COMMITTEE OF ADJUSTMENT

MINOR VARIANCE REPORT

APPLICATION: CAV A/134/2022

Owner/Applicant	Agent	Location of Land
Andrew & Hali MacDonald	Gren Weis Architect & Associates	PLAN 1009 LOT 30
152 Cavendish Court	c/o Geoffrey Roche	185 Balsam Drive
Oakville ON L6J 5S2	210-341 Kerr Street	Town of Oakville
	Oakville ON L6K 3B7

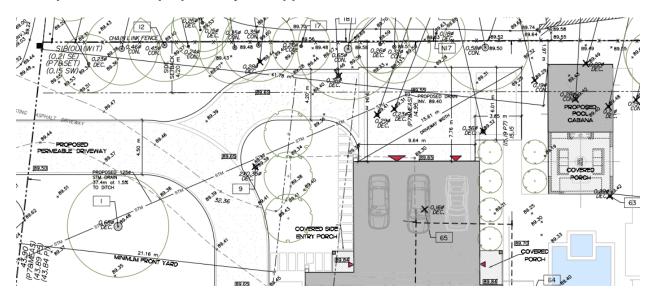
"a) The built form of development, including scale, height, massing, architectural character and materials, is to be compatible with the surrounding neighbourhood.

b) Development should be compatible with the setbacks, orientation and separation distances within the surrounding neighbourhood.

h) Impacts on the adjacent properties shall be minimized in relation to grading, drainage, location of service areas, access and circulation, privacy, and microclimatic conditions such as shadowing."
